Town of Kittery Town Planning Board Meeting March 10, 2016

Yankee Commons Mobile Home Park Expansion – Final Subdivision Plan Review

**YANKEE COMMONS EXPANSION – FINAL PLAN REVIEW
RESPONSE UPDATE - 03/10/16**

SHEET TITLE:
SUBDIVISION PLAN

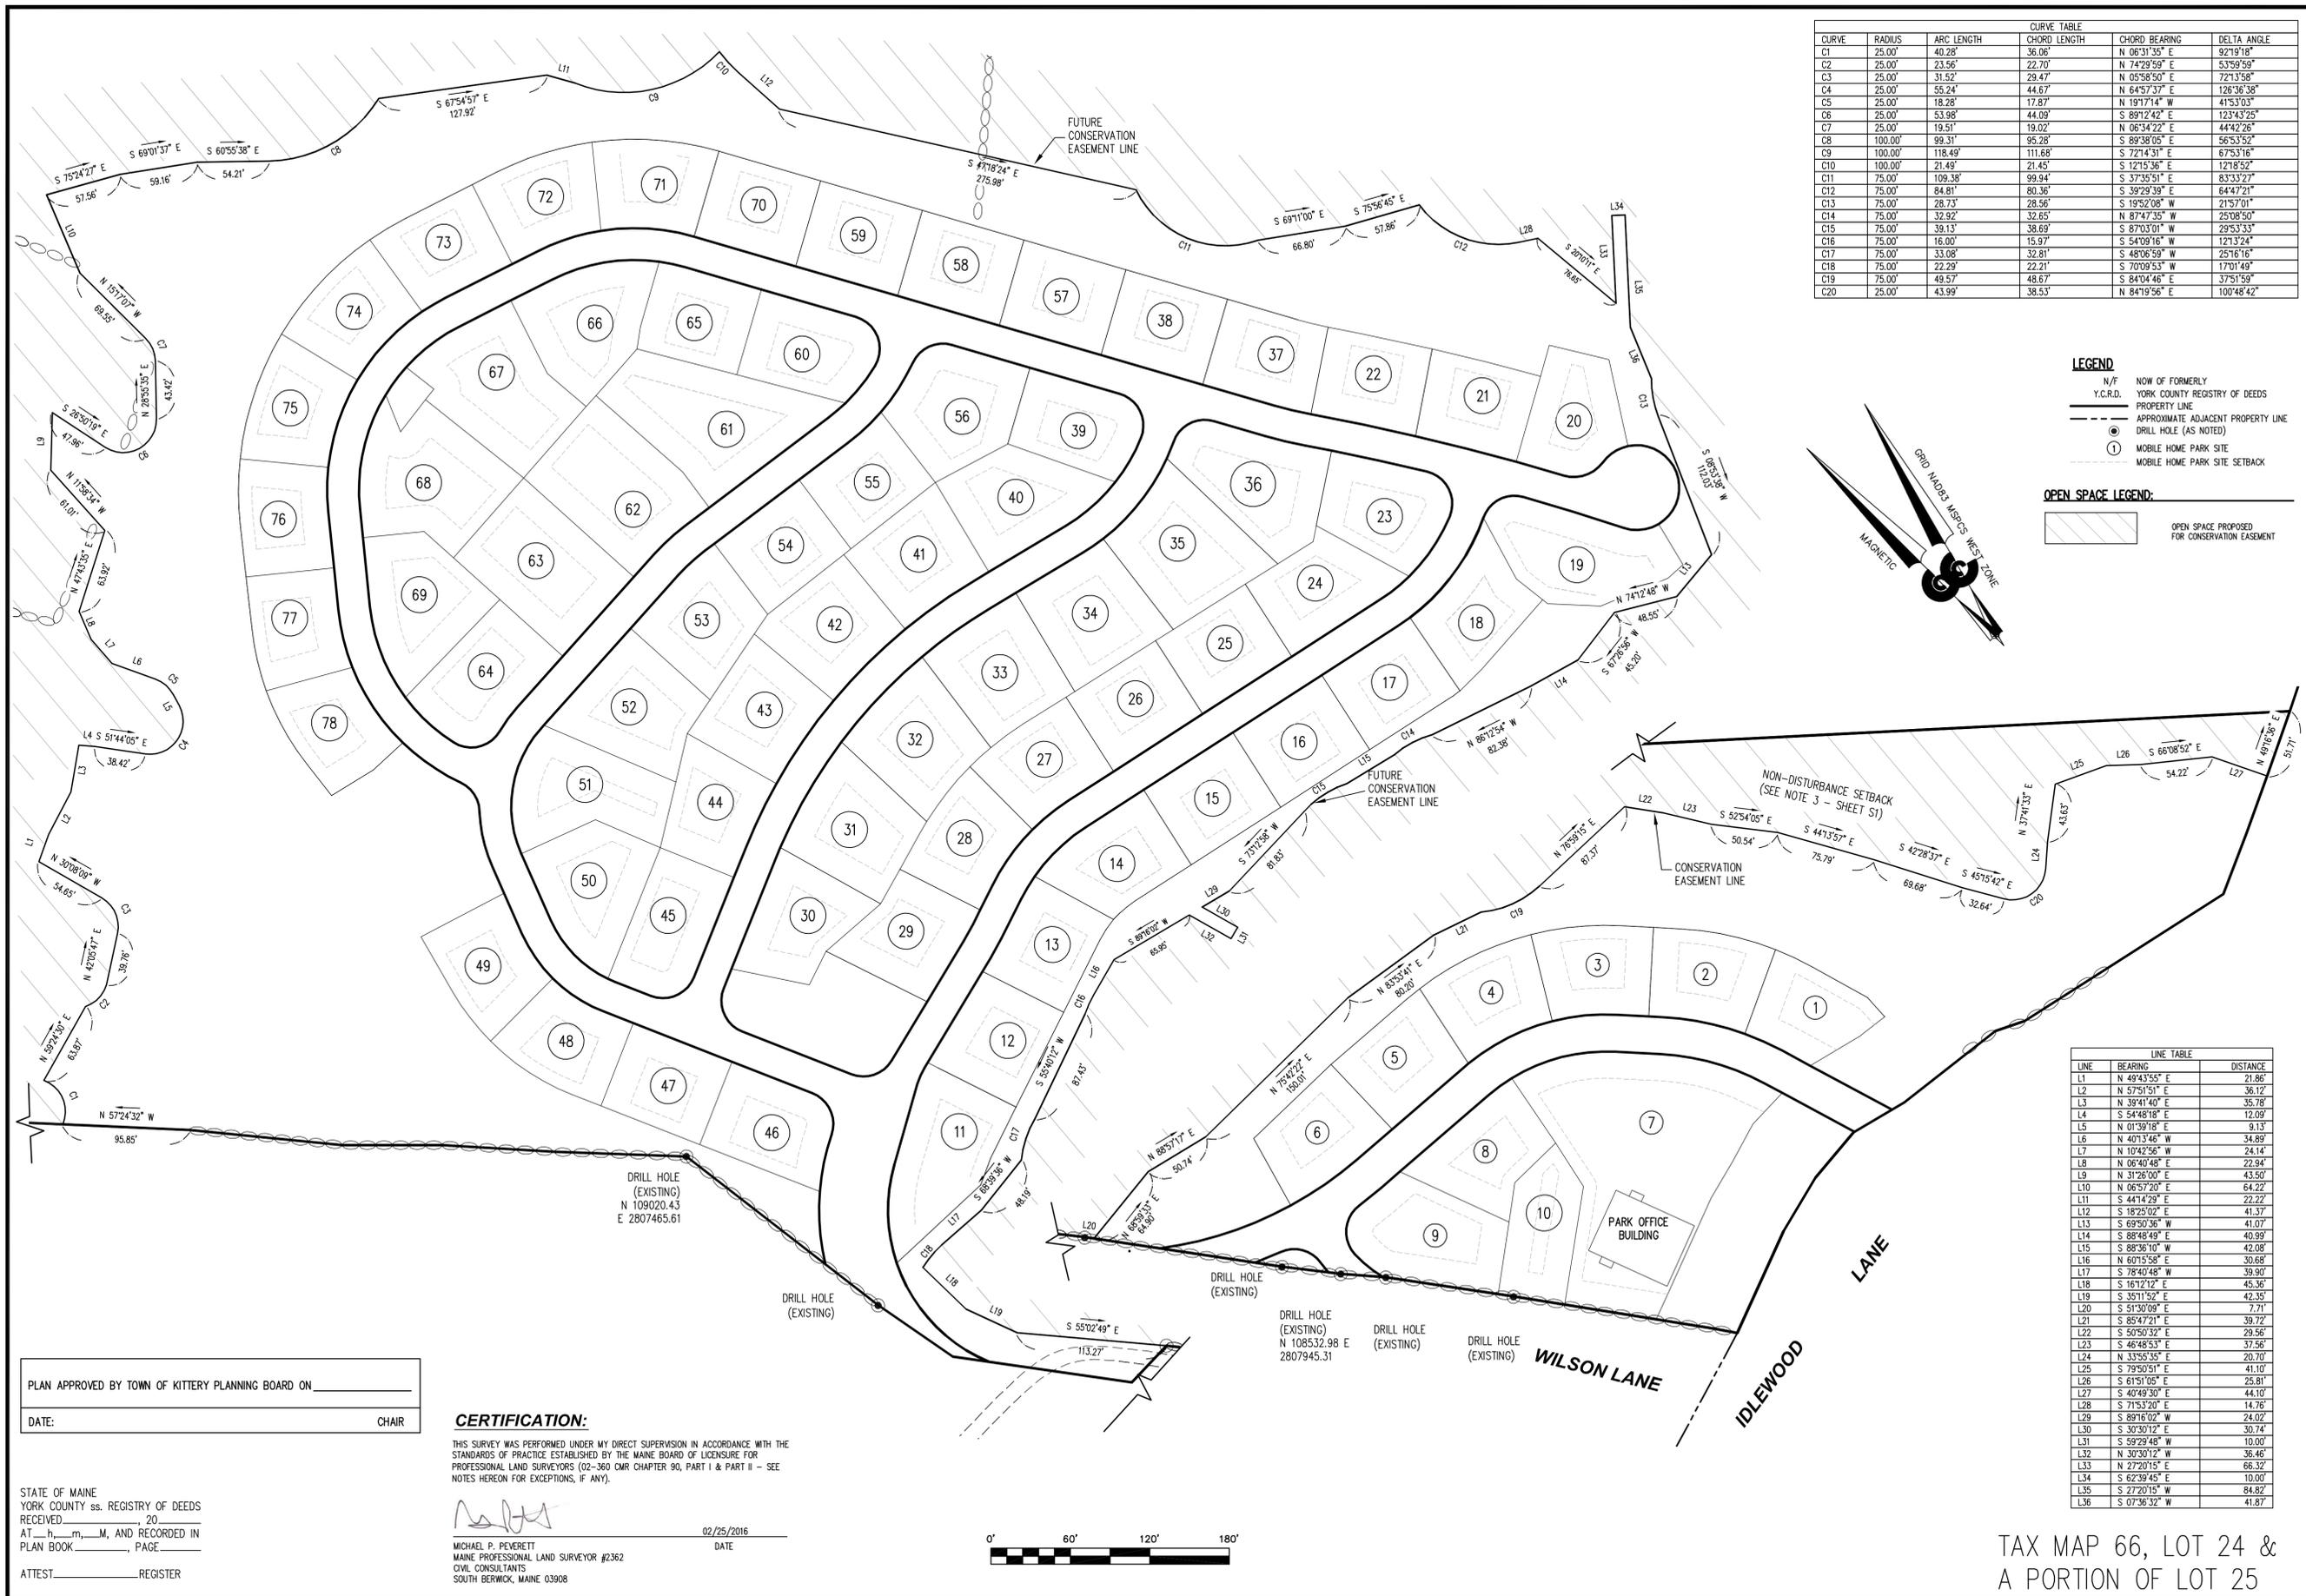
1) It appears that the required open space (10% of the total area of the lots) is not included in the proposed conservation easement (though there is a slight difference in totals between Sheet S1 and the exhibit OSP that is attached to the RTC). This may be important with regard to how the Board might consider the proposed conservation easement to the town.

5) *In the introduction of the Earth/Rock Removal Operations Plan (ERRP) it is stated the project is expected to take five years to complete. Per 16.10.9.1.4.A a subdivision plan approval will expire if the project is not complete within 3 years of planning board approval. This provision was amended in 1/28/2015, changing the 5 year period to complete a subdivision to 3 years. Since the original submission prior to the superior court appeal was reviewed under the earlier code, the 5 year period would apply. A plan note on the subdivision plan should state this, so there is no confusion later on.*

6) *The Subdivision Plan (sht-S-1) should include a plan note that addresses the "proposed conservation" easement. As mentioned under condition #7, if the "conservation easement is not executed what are the implications? Does the plan come back to the Planning Board? At this point it is not clear. Perhaps the "proposed" easement is better stated as "future" easement and/or a note that explains the intent and that it is not part of the regulatory requirements. The note might also state that it will be maintained as "open space" or as a "no-disturb area" by the mobile home park management until such time a conservation easement is executed. So the final plan's approval is in effect is not tied to the execution of the conservation easement or not. The applicant's agent has informed staff that the MDEP's stormwater permitting is not tied to the conservation easement and the land it encompasses as being maintained in a specific manner.*

8) *Though it has been evident, staff has not considered the implications until now of having the proposed development on a separate parcel under, technically, different ownership than the adjacent mobile home park, where the access to the proposed development is partially on this adjacent lot. Perhaps a note that addresses this, and the necessary access and utility easement to burden the Yankee Mobile Home Park LP property. The Subdivision Plan (S-1) should also reflect that the proposed roadway is located on the on the other property, perhaps denoted as a dashed line.*

9) *On the Subdivision Plan (S-1) notes refereeing to "no disturb" setback cites Sheet S-1, note 4, however, it is evident it is refereeing to another note on another sheet. The plan needs to be revised, perhaps "S-1" was meant to be "C-2". Same reference is also found on Sheet C-2, however, plan note #4 seems more applicable. It reads: The non-disturbance setback shown hereon is either 75' emergent wetland setback, the 100' stream setback or the 25' wetland setback." It is not clear which one applies on the plan. Staff recommends that there is a single "no*

disturb” setback line depicted on the plan(s). This line may have to cover other regulatory lines, however, it would be clear as to where the “no-disturb” land is, especially important during construction.

UPDATE: The applicant has added plan note #8 to Sheet S-1 (Subdivision Plan) to address this comment.

UPDATE: The applicant has added plan note #12 to Sheet S-1 (Subdivision Plan) to address this comment.

UPDATE: The applicant has added plan note #8 to Sheet S-1 (Subdivision Plan) to address this comment.

UPDATE: The applicant has added plan note #13 to Sheet S-1 (Subdivision Plan) to address this comment.

UPDATE: The applicant has clarified the line type used on Sheet S-1 (Subdivision Plan) to address this comment.

152 A note (#8) has been added to plan sheet S1 regarding the consequence of council inaction. This note
153 reads as follows:

154 A FUTURE CONSERVATION EASEMENT FOR THE UNDISTURBED OPEN SPACE IS TO BE MANAGED AS
155 A NO CUT / NO DISTURVANCE AREA UNTIL SUCH TIME AS AN EASEMENT IS ACCEPTED BY THE TOWN
156 OF KITTERY OR FURTHER APPROVAL ACTION IS GRANTED BY THE KITTERY PLANNING BOARD.
157 MARKERS ARE TO BE INSTALLED ALONG THE BOUNDARY OF THE CONSERVATION EASEMENT AS
158 SHOWN HEREON BEFORE CONSTRUCTION BEGINS. SEE SHEET S2 FOR A FUTURE CONSERVATION
159 EASEMENT LAYOUT.
